This Service Information bulletin supersedes SI B64 04 12 **dated October 2012.**

Blower Makes an Unusual Noise

F30

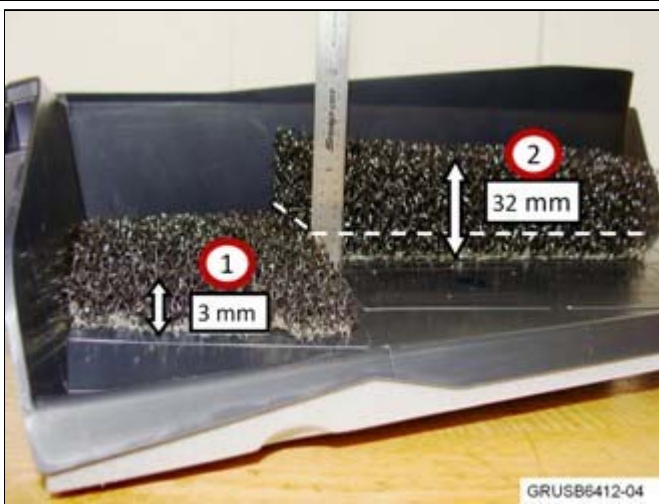
| | <ol style="list-style-type: none"> NEW Remove the cover (1) by loosening the three fasteners circled in red, and then remove the side panel trim piece (2) by |

removing the 3 expanding rivets circled in yellow.

7. **NEW** The windshield cowl panel (3) must be loosened to better access the fresh air intake cover. Release the five fasteners circled in red, and then remove the expanding rivet shown by the white arrow.

8. **NEW** The fresh air intake cover (4) must be removed. Disconnect the sensor shown by the white arrow and remove the two fasteners circled in black.

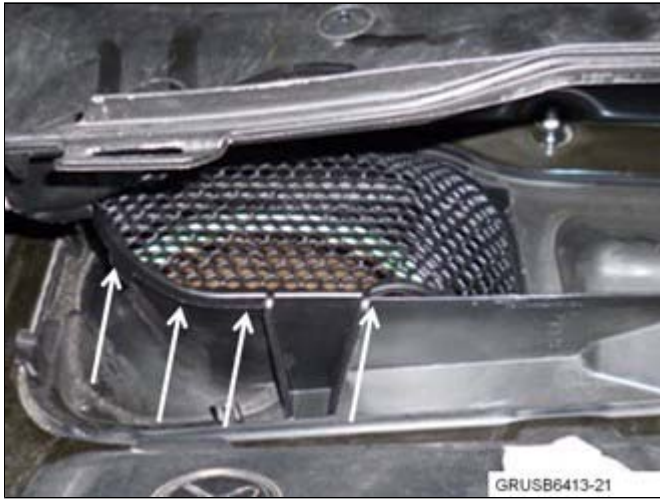
9. **NEW** Inspect the underside of the removed fresh air intake cover. The two foam pieces attached confirms it has the early version kit installed. Remove these two foam strips.

10. **NEW** The basket (P/N 64 31 9 296 394) must also be removed and discarded. After removal, be certain to check and remove all remaining debris, such as leaves and sticks, from the exposed area of the blower opening.
11. **NEW** The next step describes the installation of the new repair screen.

12. **NEW** The new repair screen (P/N 64 31 9 321 616) contains a more robust honeycomb grid that provides better protection from debris. Fit the new screen over the blower opening and rotate underneath the cowl.

13. **NEW** Check for proper fitment of the screen and ensure it is properly fitted to the upper dividing wall, as shown by the white arrows.
